**TOWN OF NEWBURGH
PLANNING BOARD
TECHNICAL REVIEW COMMENTS**

PROJECT: HEALY KIA
PROJECT NO.: 19-25
PROJECT LOCATION: SECTION 95, BLOCK 1, LOT 54.2
REVIEW DATE: 9 JANUARY 2020
MEETING DATE: 16 JANUARY 2020
PROJECT REPRESENTATIVE: DAY & STOKOSA ENGINEERING P.C.

Re: Town File No. 2019-25
Amended Site Plan for Healey Kia
NYS Route 17K,
Town of Newburgh

SITE PLAN

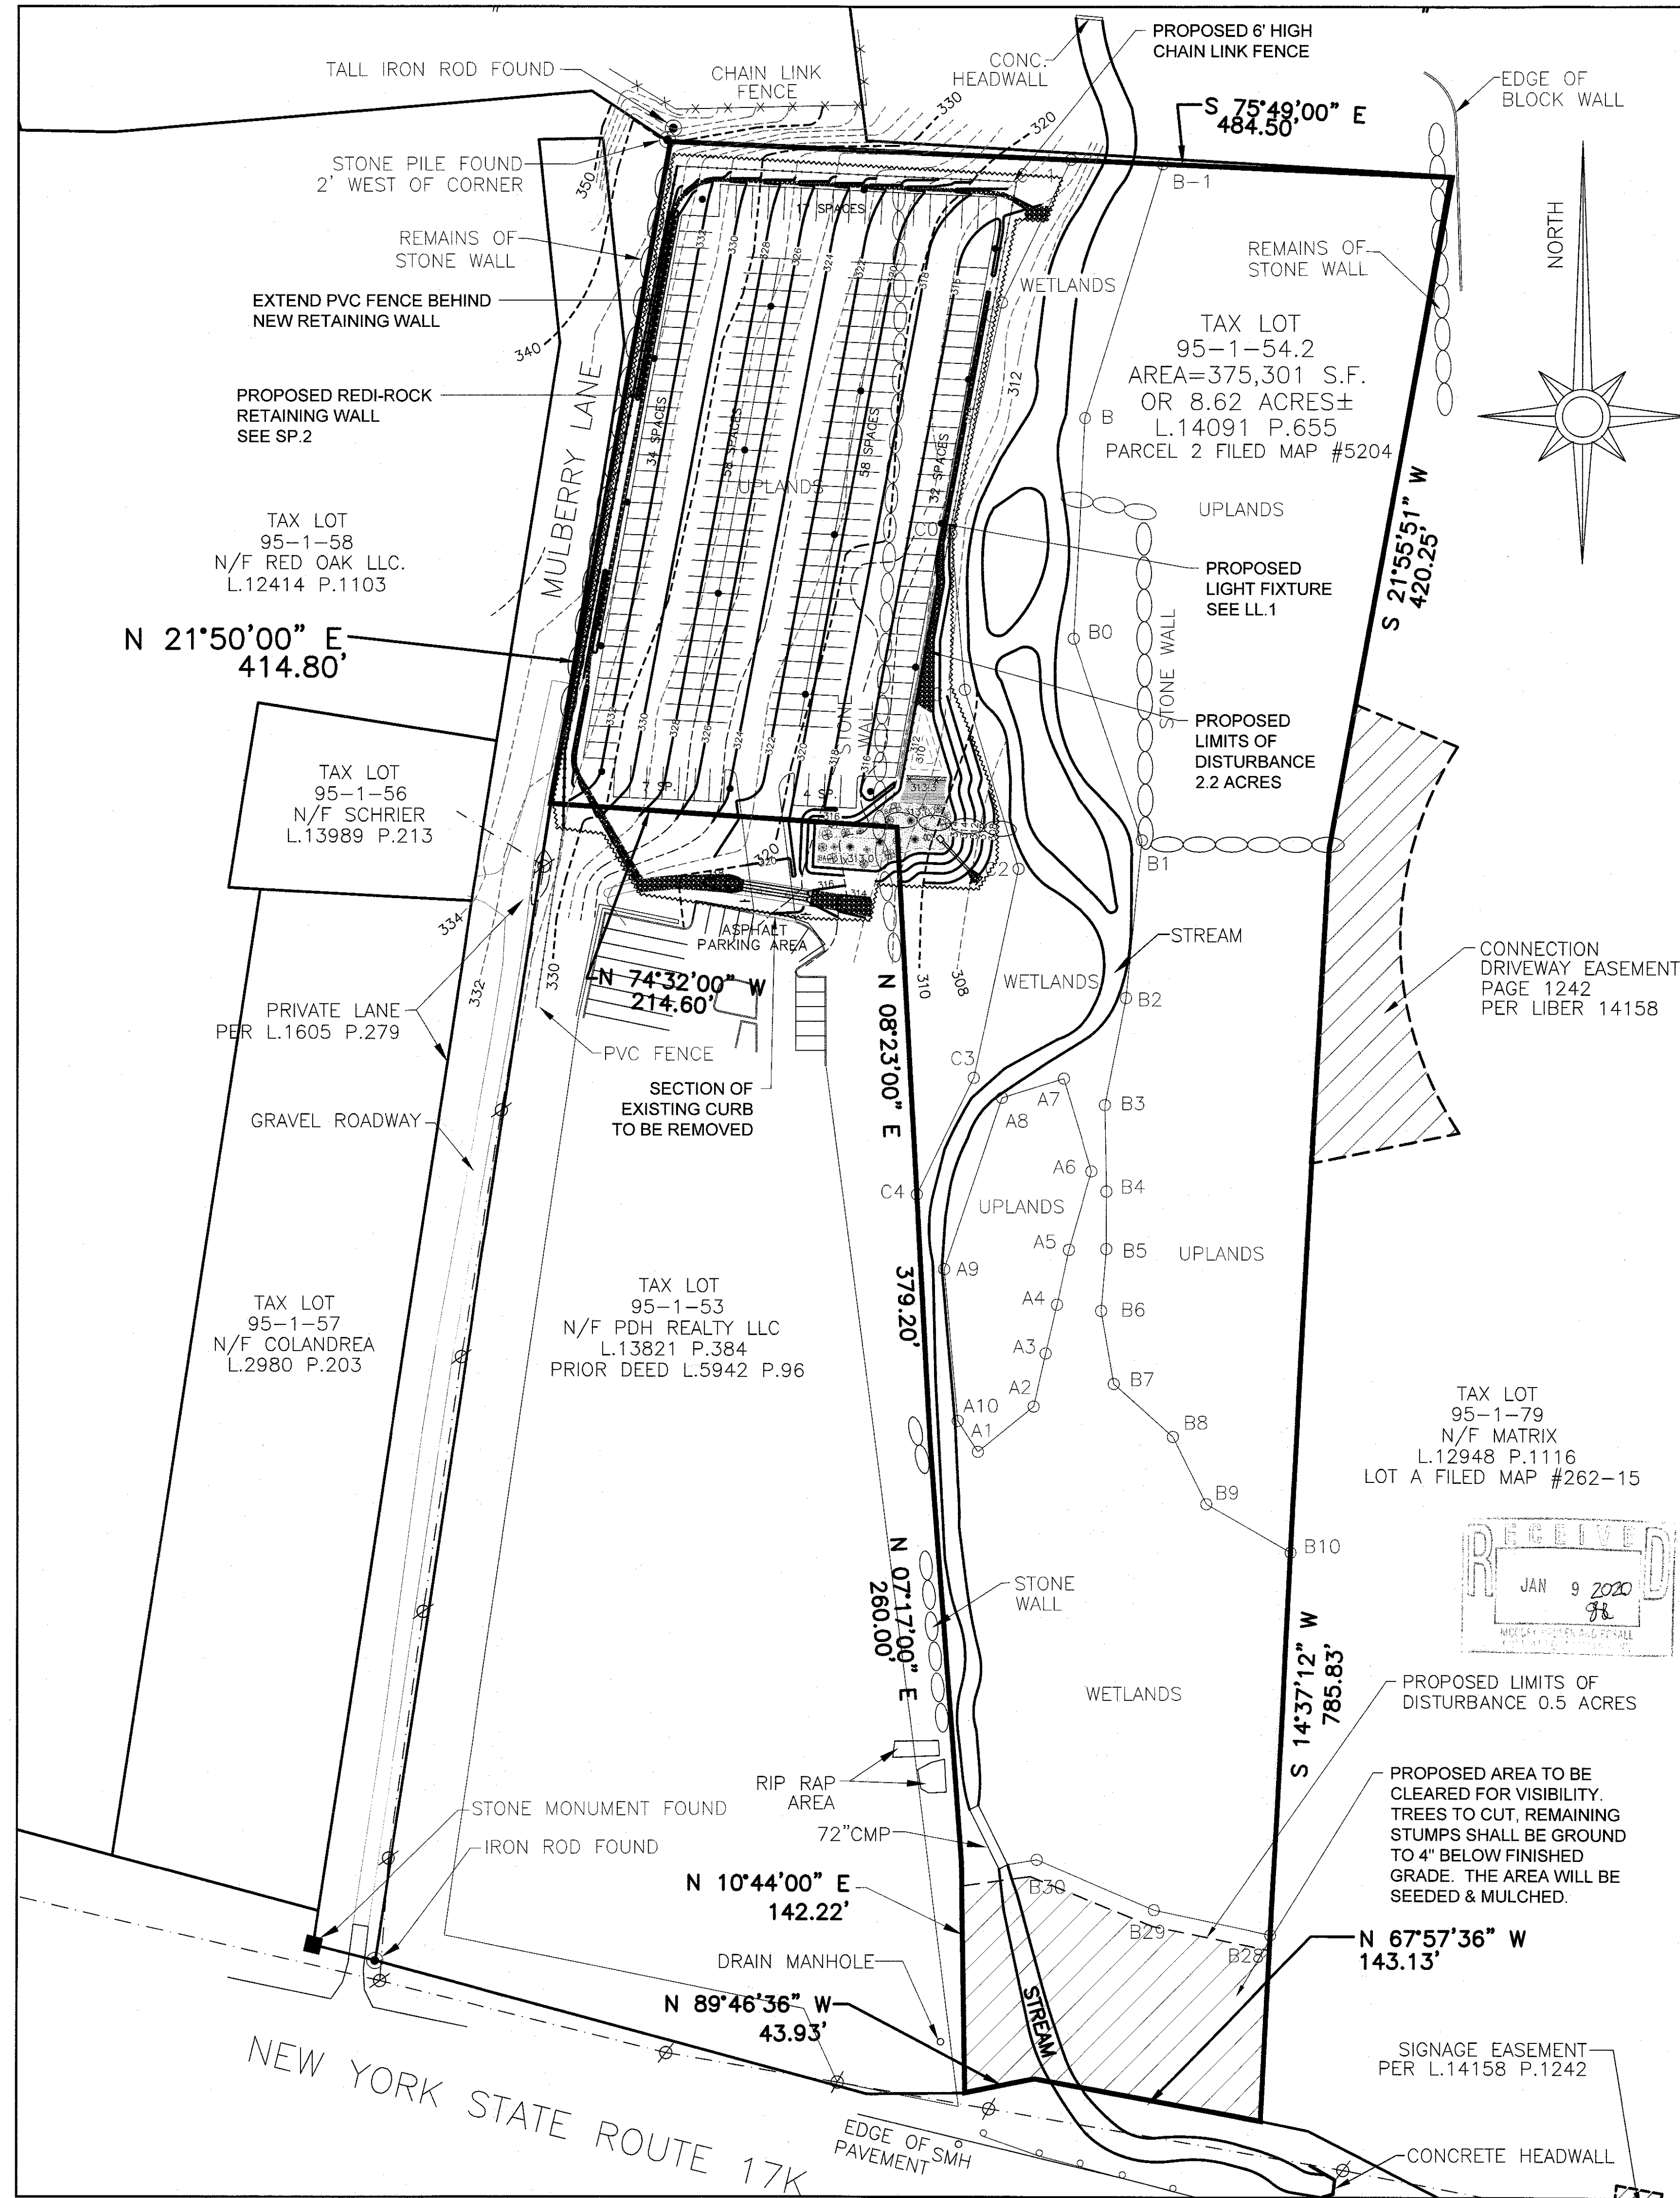
9. Notes should be added to the plans identifying what the sites will operate as a unified site plan and tying the approvals to the current property use of the Kia dealership. Any change in the use of any property should eliminate the adjoining parking spaces without further approvals or action by the Town.

Response: A note stating "The approved sites shall operate as a unified site plan and so tying the approvals to the current property use of the Kia dealership. Any change in the use of either property will eliminate the adjoining parking spaces without further approvals or action by the Town." has been added to sheet SP.1.

NOTE: THE APPROVED SITES SHALL OPERATE AS A UNIFIED SITE PLAN AND SO TYING THE APPROVALS TO THE CURRENT PROPERTY USE OF THE KIA DEALERSHIP. ANY CHANGE IN THE USE OF EITHER PROPERTY WILL ELIMINATE THE ADJOINING PARKING SPACES WITHOUT FURTHER APPROVALS OR ACTION BY THE TOWN OF NEWBURGH.

D.1 8 FT BLACK CHAIN LINK FENCE DETAIL
 Det.1 SCALE: NOT TO SCALE

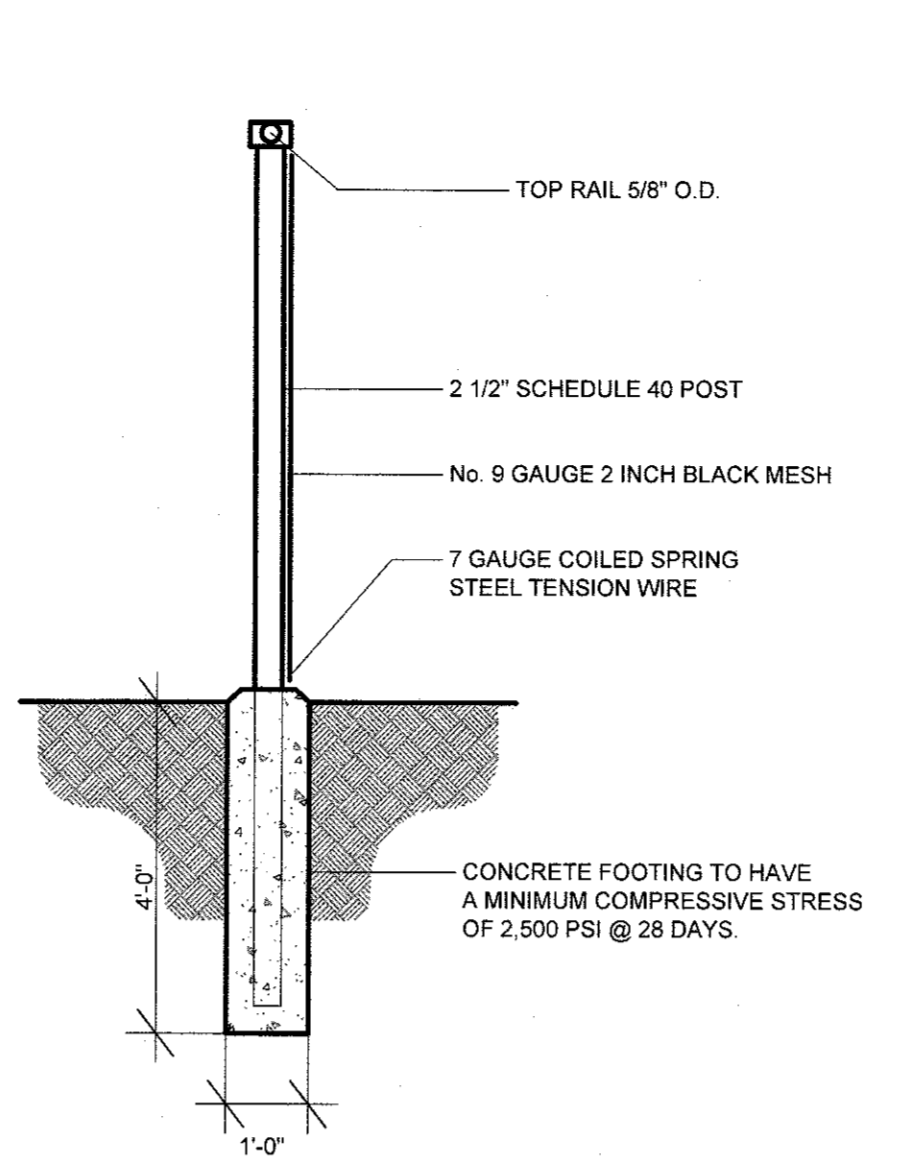
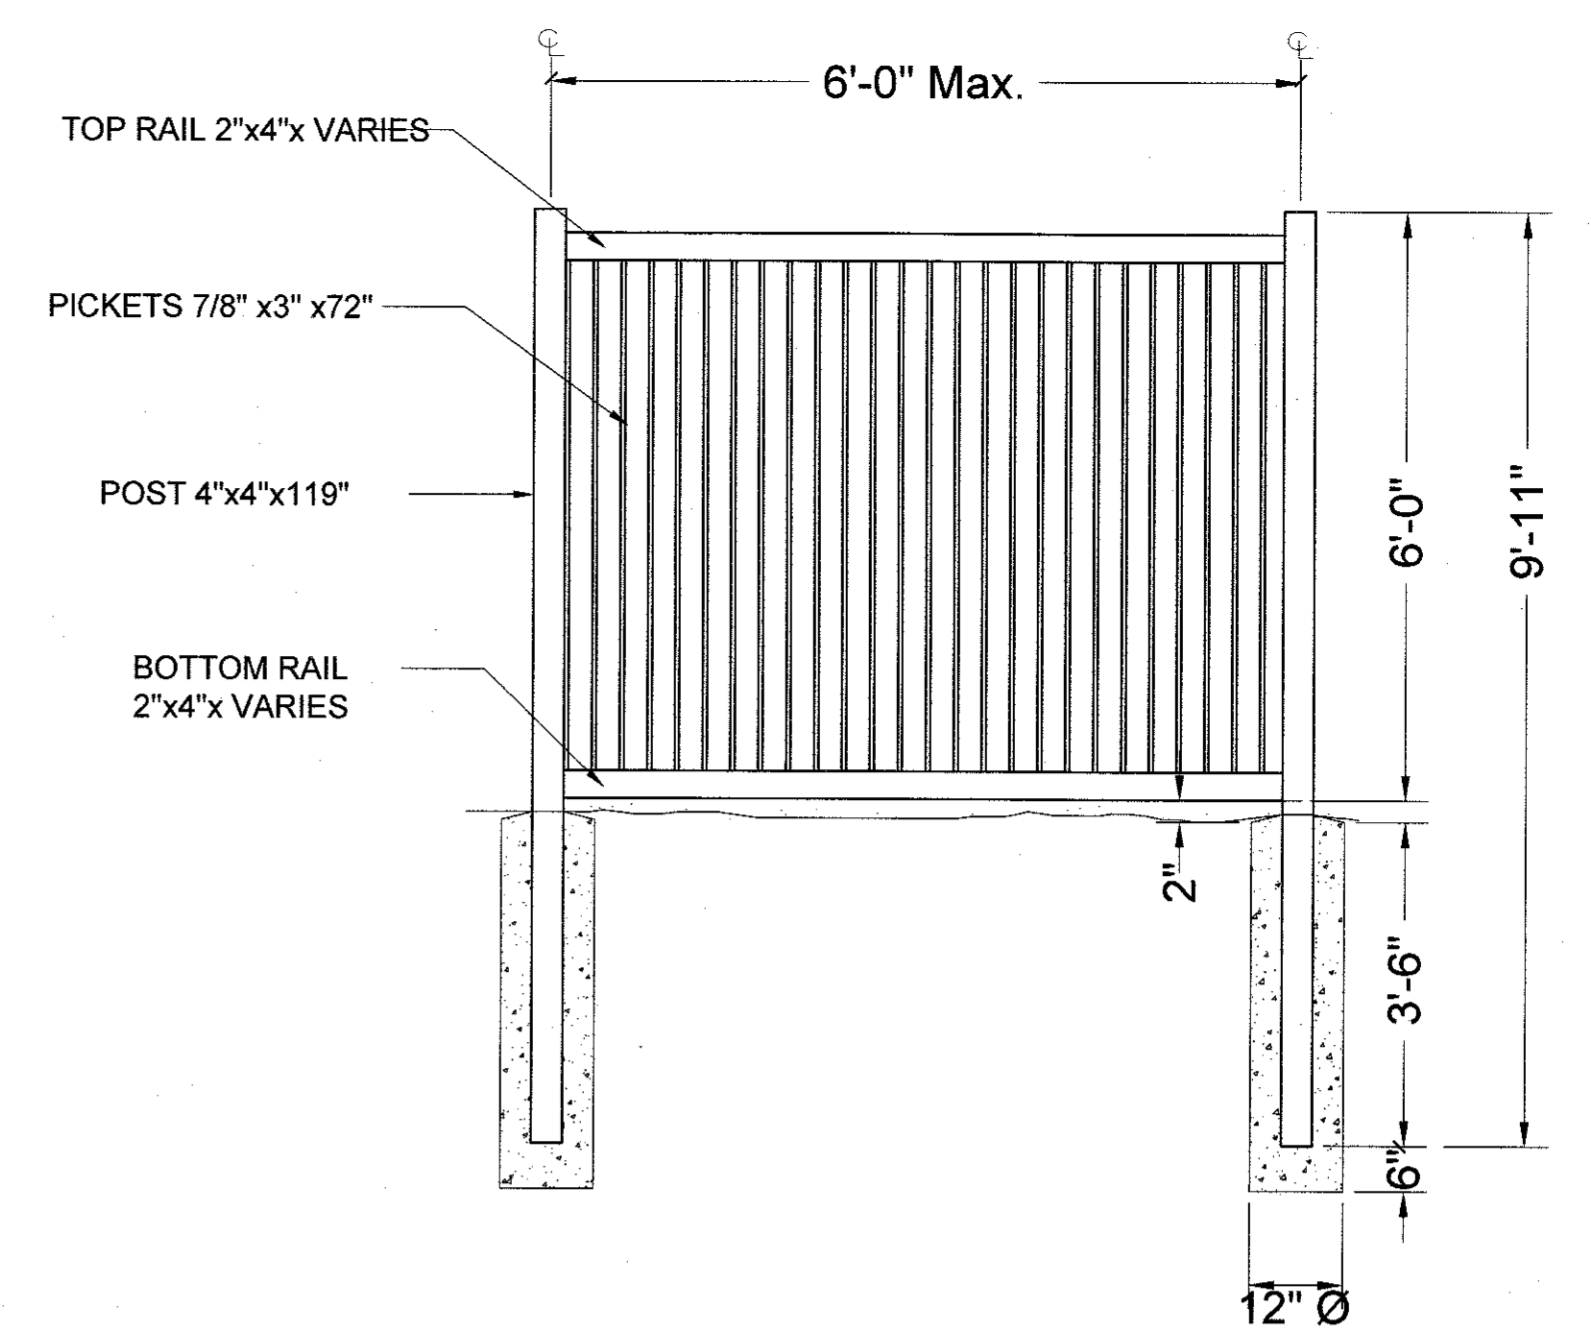
5. The narrative submitted appears to identify that the access will be gated and fenced. The plans do not depict fencing between the existing lot and the proposed inventory parking lot.

7. Previously the Planning Board restricted access by the public to the overflow parking areas which were not constructed of conventional asphalt pavement. Appropriate signage and gates should be provided should the Board wish to consider the off-site use.

Response: A continuous chain link fence with an entrance gate and appropriate signage has been provided to restrict access to the inventory only parking lot.

1 LIGHTING PLAN
 Det.1 SCALE: 1" = 40'

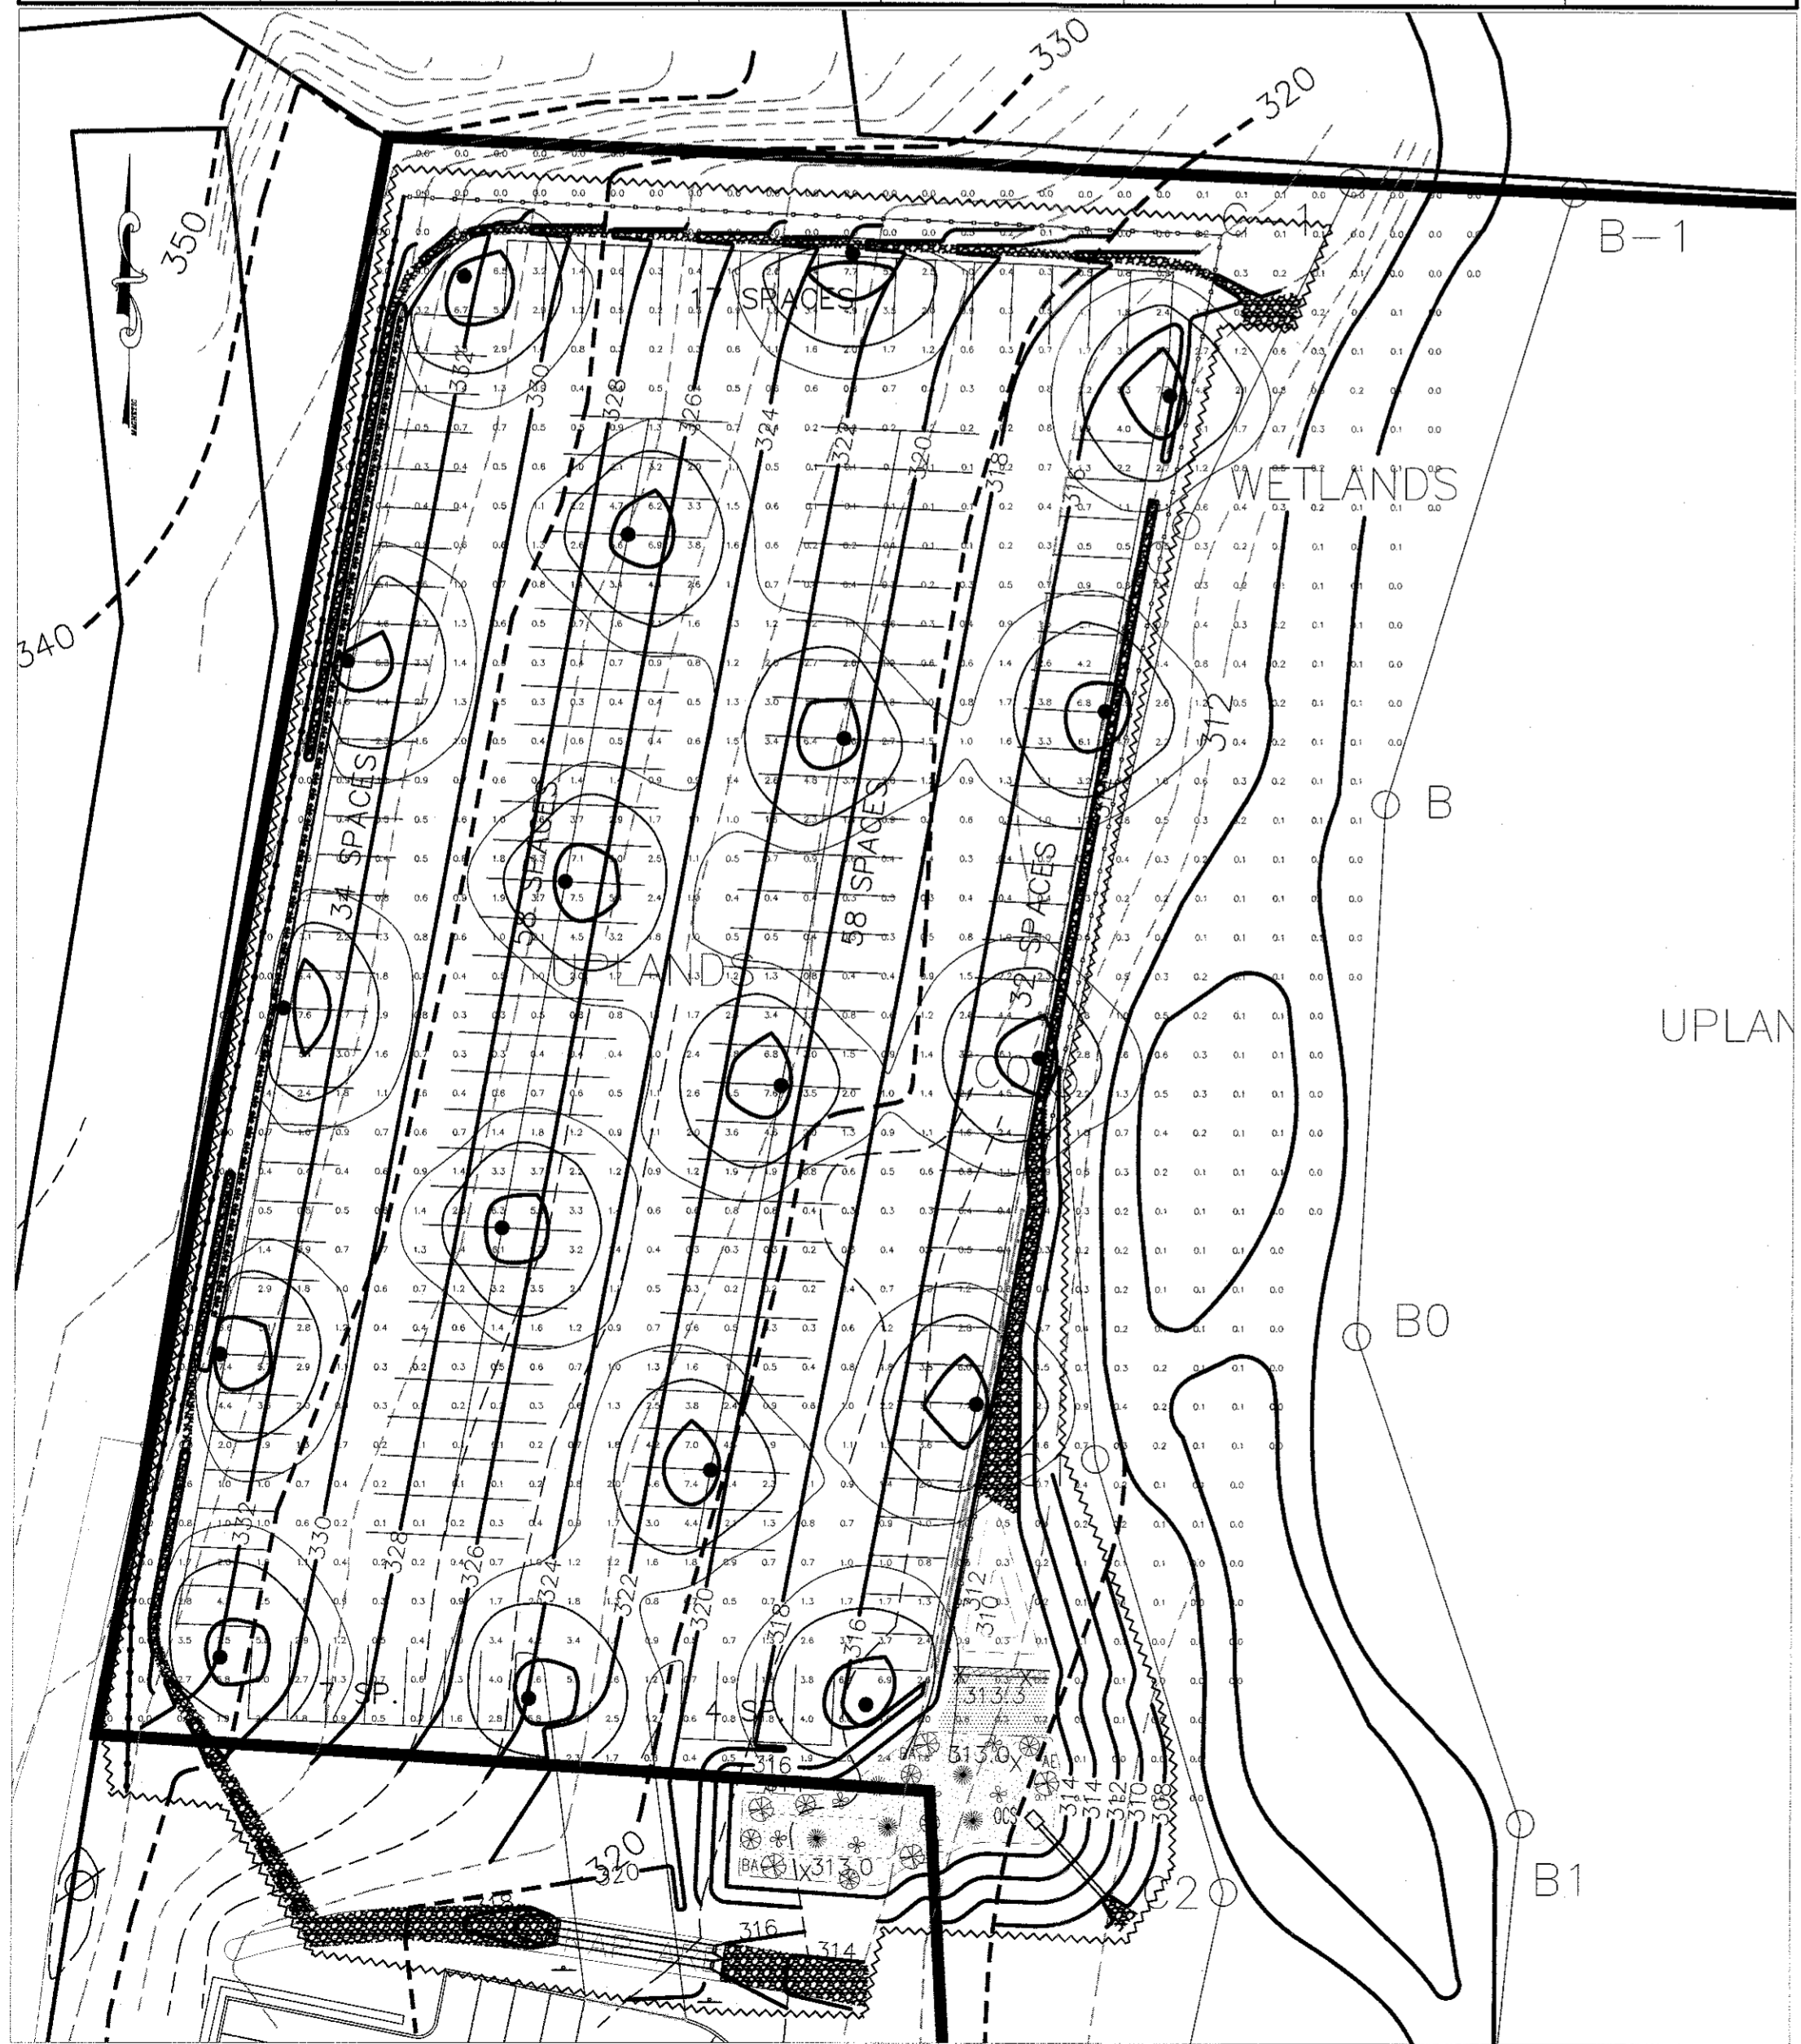
3. Height of the light poles should be submitted to the FAA for a no obstruction to aviation determination.
4. The project must be submitted to the Orange County Planning Department once the comments regarding Stormwater Management below have been addressed.
